The petition proposes to allow the development of the Charlotte Hornets practice facilities and associated accessory uses on a lot that is currently used as surface parking.

Staff recommends approval of this petition upon resolution of outstanding issues related to transportation, site and building design, and the environment in addition to requested technical revisions.

The site plan accompanying this petition contains the following provisions:

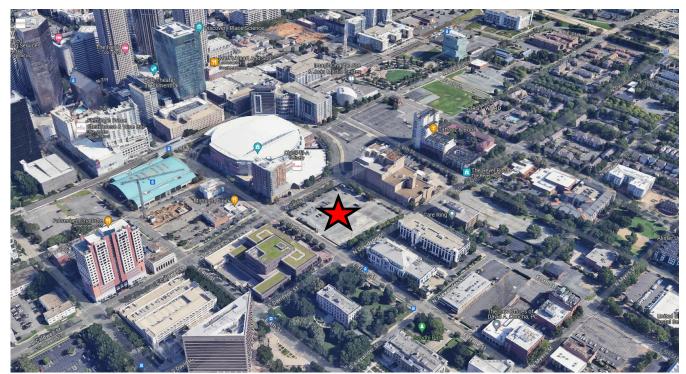
- 1. Recommit to provide the public parking spaces, otherwise the location of the future curb and gutter along N. Caldwell Street needs to be moved 7' from the existing curbline as stated in the Streets Map.
- 2. Along N. Davidson Street, the location of the future curb and gutter needs to be moved 7' from the existing curbline. On the site plan callouts, remove the word "optional" regarding the 7' to the future back of curb measurement.
- 3. Revise the EX provision to Article 33.3 to remove N. Davidson Street as being exempt to the Streets Map standards.
- 4. Revise the site plan and conditional notes to have the sidewalk alignment be consistent across the site's entire N. Davidson Street frontage.

- 5. Due to the site's prominent visibility and the nature of EX requests, modify the notes committing to a public art feature to the following, "The petitioner shall utilize no less than two (2) City of Charlotte Placemaking Creative Pool artists from a list managed by the UDC to incorporate public art into the site's overall design. Selection/curation and location of public art features shall be subject to the approval by the City's Urban Design Center (UDC)."
- 6. Provide notes on the 250 parking spaces and detail what restrictions are being proposed.
- 7. Collaborate with the Urban Forestry team on the EX provision language for Article 20.17.

8. State the purpose of the limited access driveway in the conditional notes.

9. In "e" of the general provisions, separate out the language regarding storm water and urban forestry into two separate notes.

10. Add language stating that the requested EX provisions in this conditional plan are only applicable for sporting facilities and accessory uses on the site.
